Memorandum

Planning & Development Services Division

RE: **P.Z. 04-2016 US Ice Sports Complex & Valley Gates (Topgolf USA Chesterfield LLC)**: A request for a zoning map amendment from an existing "PC" Planned Commercial District to a new "PC" Planned Commercial District for 22.22 acres located north of North Outer 40 Road and east of Boone's Crossing (17T510041, 17T520062, 17T520095, 17T520084).

SHEET TITLE:
PRELIMINARY DEVELOPMENT PLAN

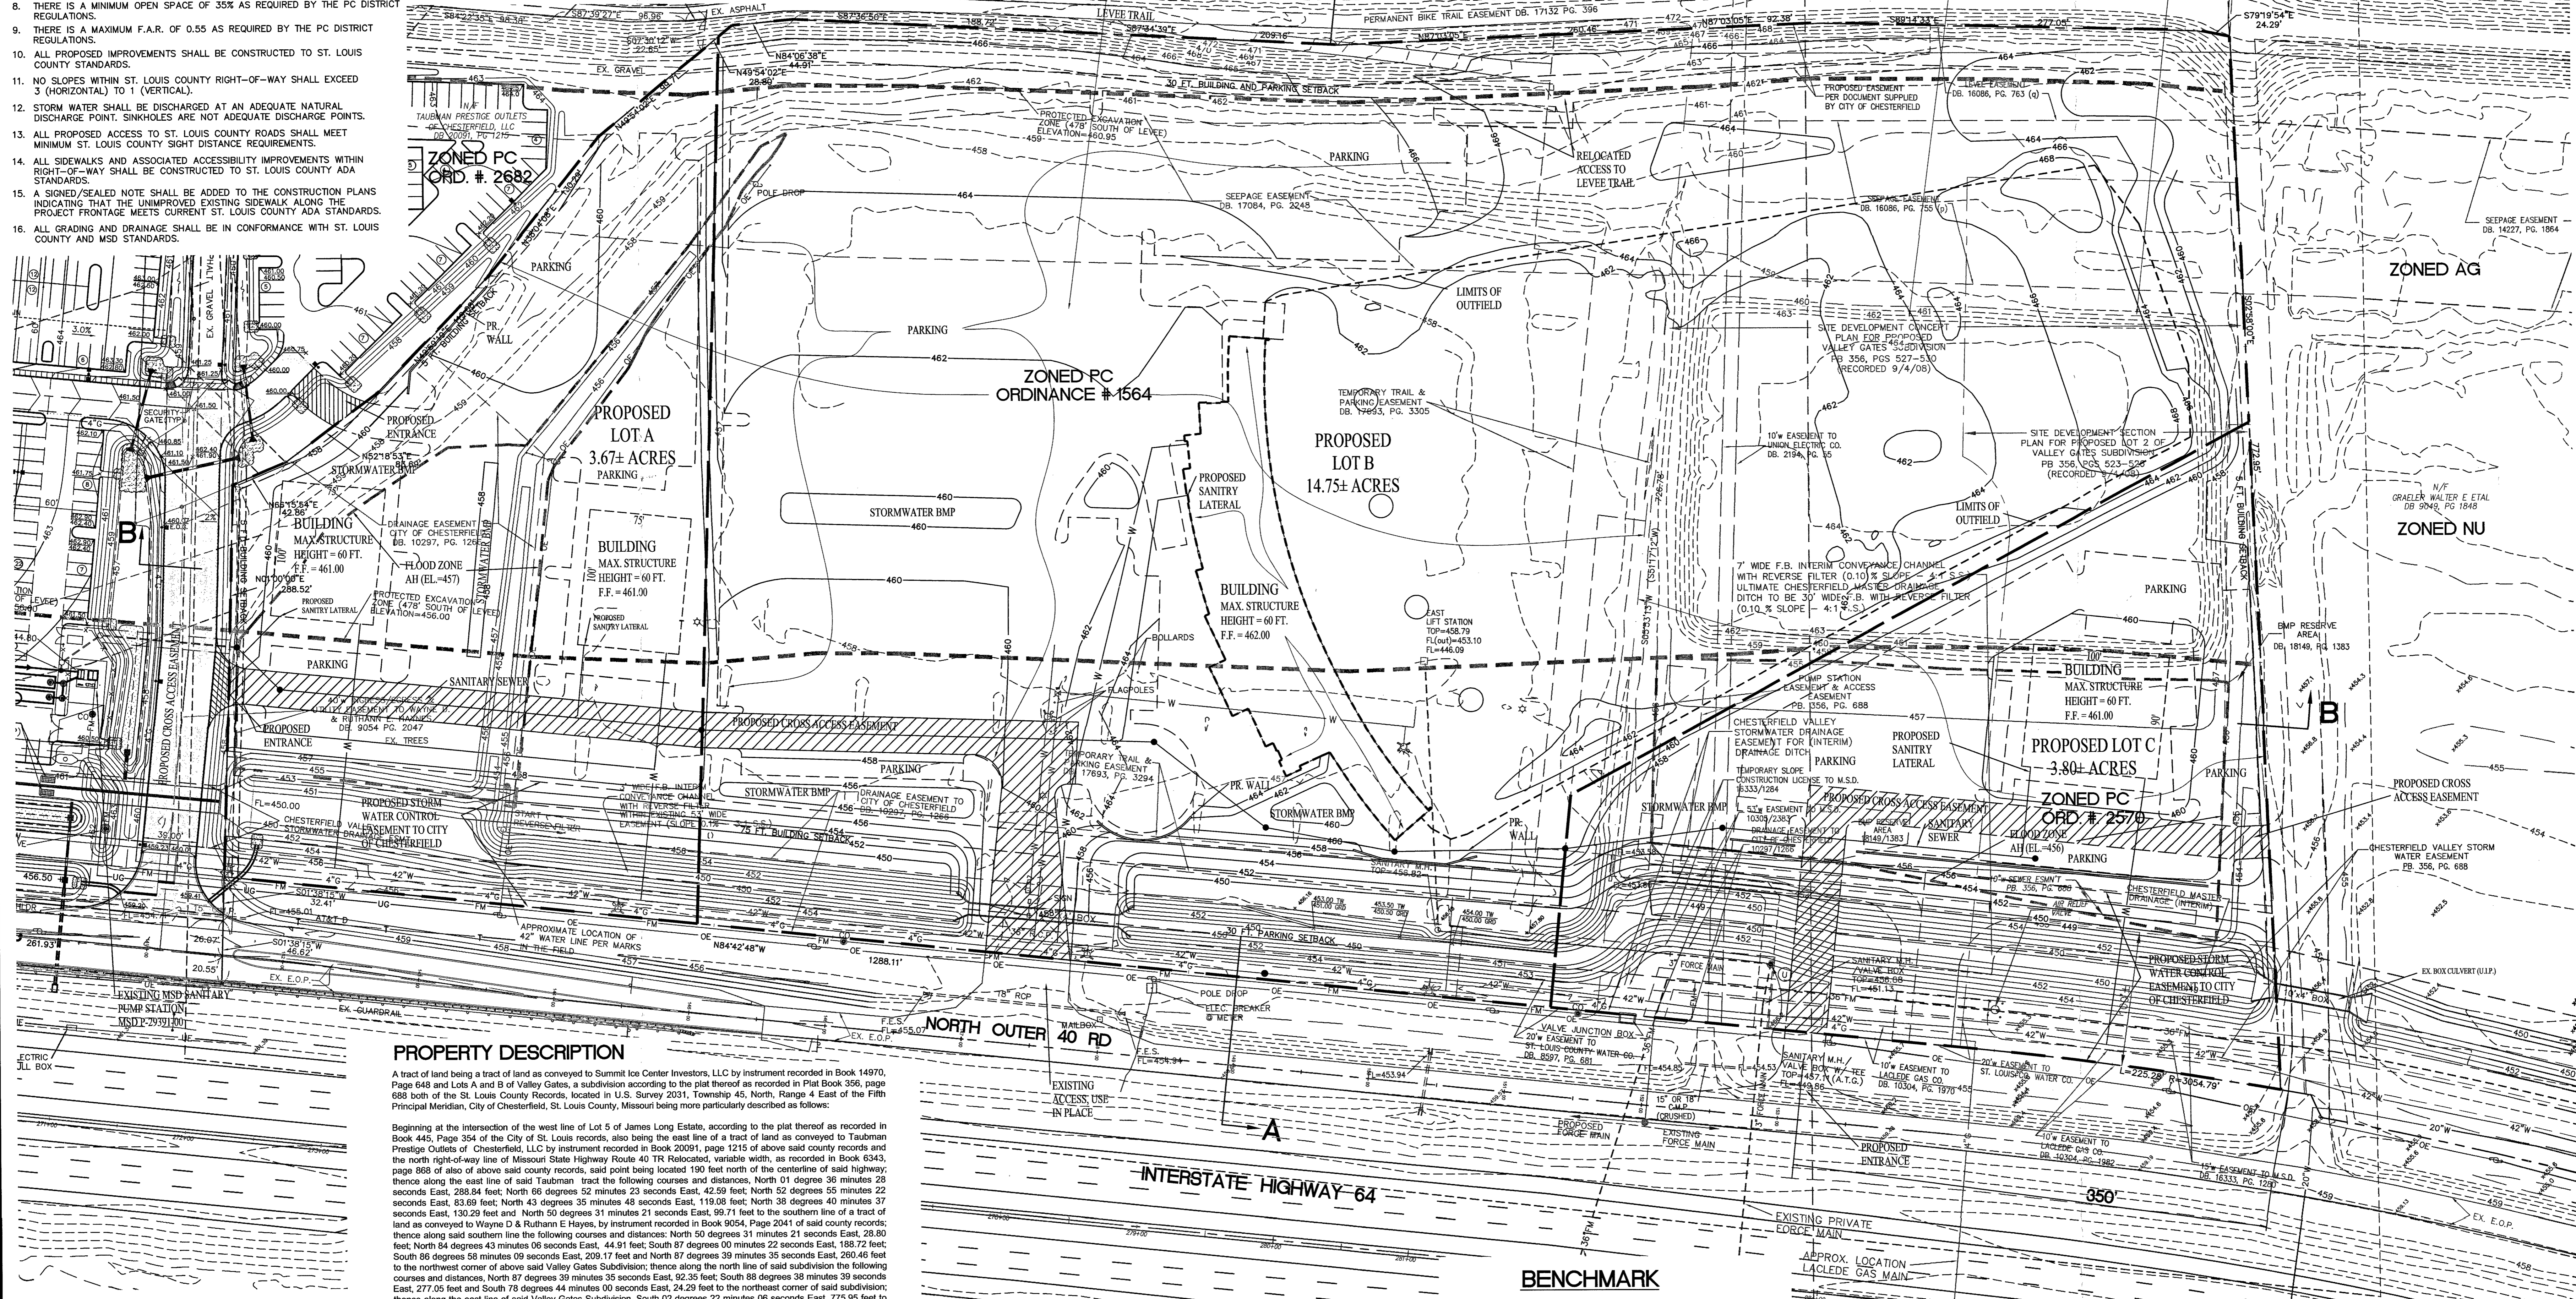
Staff has reviewed the revised proposal which includes a new curt cut, two new lots, and three new buildings. Red line changes to the Attachment "A" are found on pages 2, 3, 5, and 6. The new Preliminary Plan has been also been reviewed by the St. Louis County Department of Transportation. Staff has no concerns with the revised Preliminary Plan and if the committee accepts the revised Attachment "A", this project will be ready for City Council review.
